ENERGY UPGRADES
MILFORD COURTHOUSE
MILFORD, CONNECTICUT
PROJECT: BI- 2B - 315

BID OPENING	**1:00 P.M.**	**MARCH 31, 2010**
ADDENDUM NUMBER 3	**DATE OF ADDENDUM**	**MARCH, 19, 2010**

BID OPENING	**1:00 P.M.**	**MARCH 31/2010**
ADDENDUM NUMBER 2	**DATE OF ADDENDUM**	**MARCH, 18, 2010**

BID OPENING	**1:00 P.M.**	**MARCH 31, 2010**
ADDENDUM NUMBER 1	**DATE OF ADDENDUM**	**MARCH, 18, 2010**

5 TYPICAL GUARDRAIL DETAIL

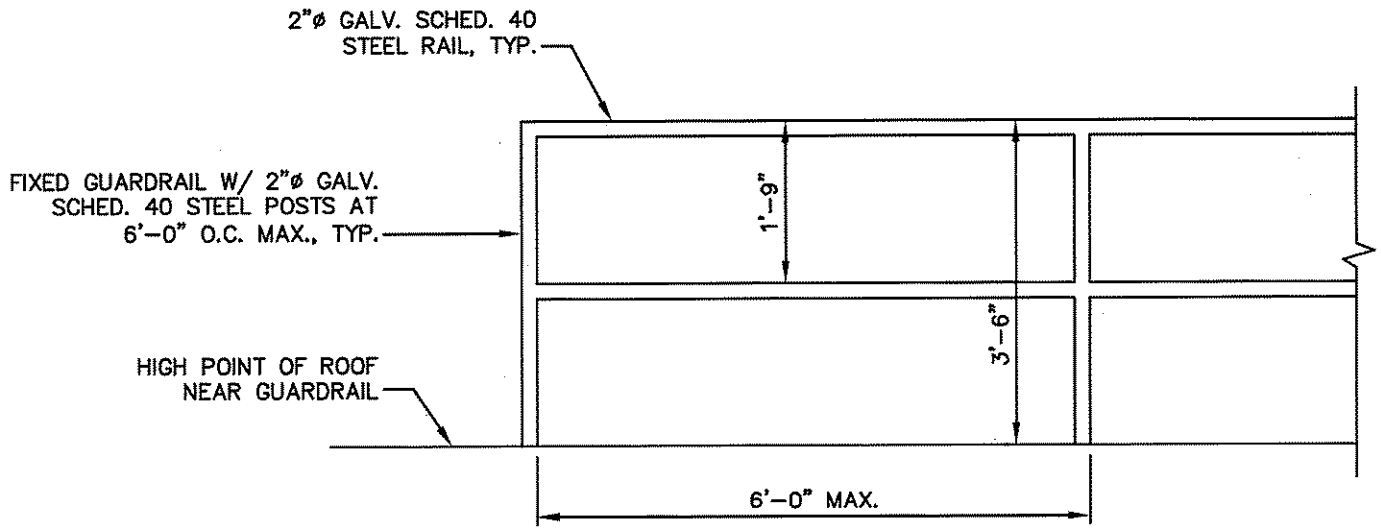
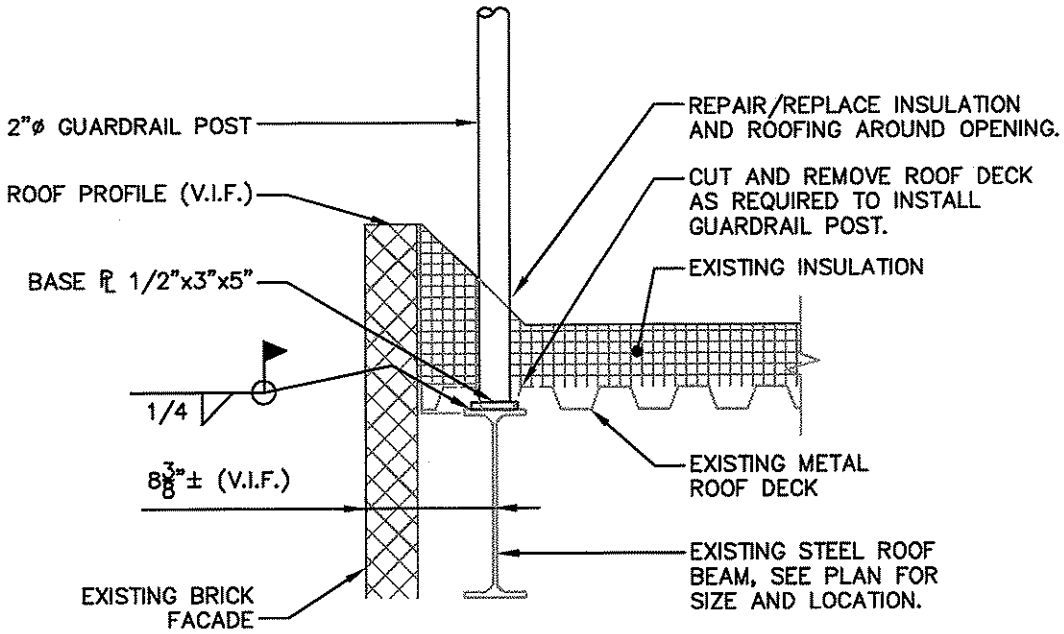
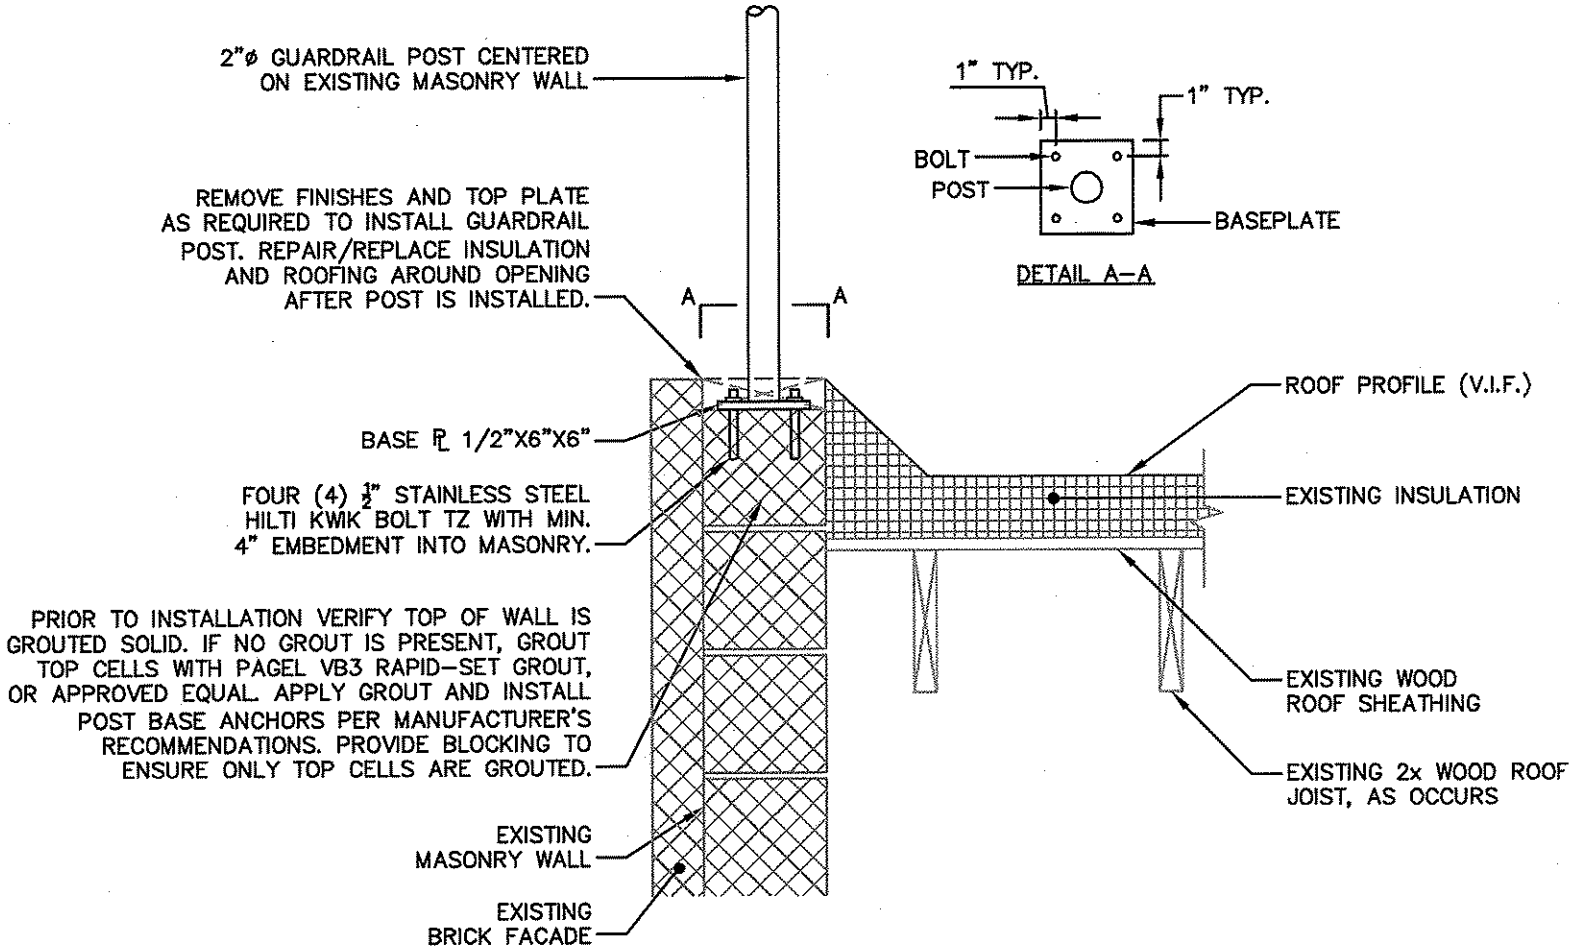
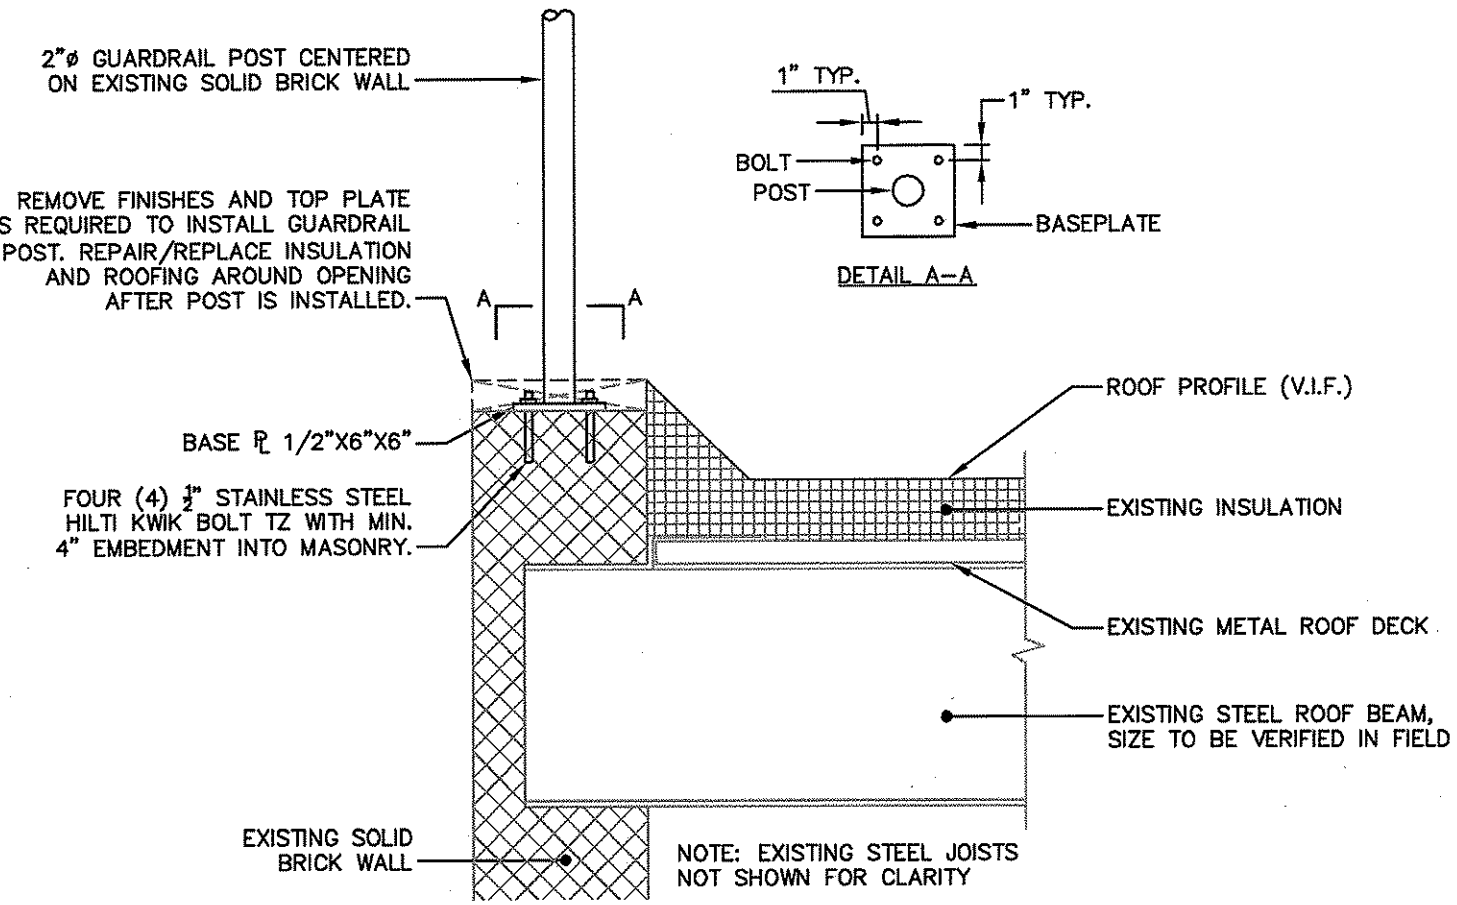
NOTES:
1. SEE DETAILS 6/SK-S07, 7/SK-S08, AND 8/SK-S09 FOR POST CONNECTIONS TO EXISTING STRUCTURE.
2. POST AND HORIZONTAL RAIL DIMENSIONS ARE TYPICAL U.N.O.

SKME1.0

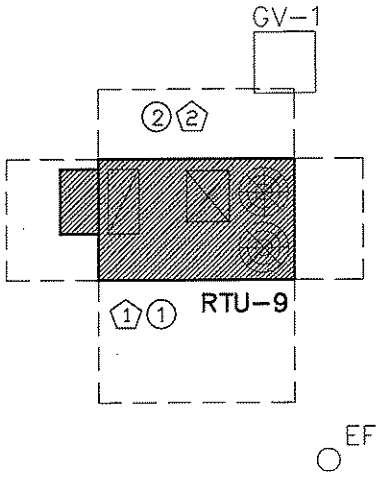
Add Alternate #1, RTU-9 replacement to scope of work on drawing M-1. Additional scope of work for Alternate #1 is indicated on attached sketch SKME-1.0. Break out price of work for RTU-9 replacement, and provide a separate cost for the Alternate #1.

1. REMOVE EXISTING ROOFTOP UNIT AND REPLACE WITH NEW RTU-9.
2. PROVIDE CURB ADAPTER. PERFORM FIELD MEASUREMENTS OF EXISTING CURBS PRIOR TO ORDERING ADAPTER CURBS. MODIFY AND EXTEND GAS PIPING AS REQUIRED FOR CONNECTION TO NEW RTU.

1. EXISTING ELECTRICAL BRANCH CIRCUIT ASSOCIATED WITH MECHANICAL EQUIPMENT SHALL REMAIN IN PLACE FOR CONNECTION TO NEW EQUIPMENT.
2. PROVIDE FINAL CONNECTION TO NEW EQUIPMENT. CHANGE CIRCUIT BREAKER FOR EXISTING BRANCH CIRCUIT TO 60 AMP, 208 VOLT, 3-POLE IN EXISTING POWER PANEL. CONDUIT AND CONDUCTORS SHALL BE REUSED.
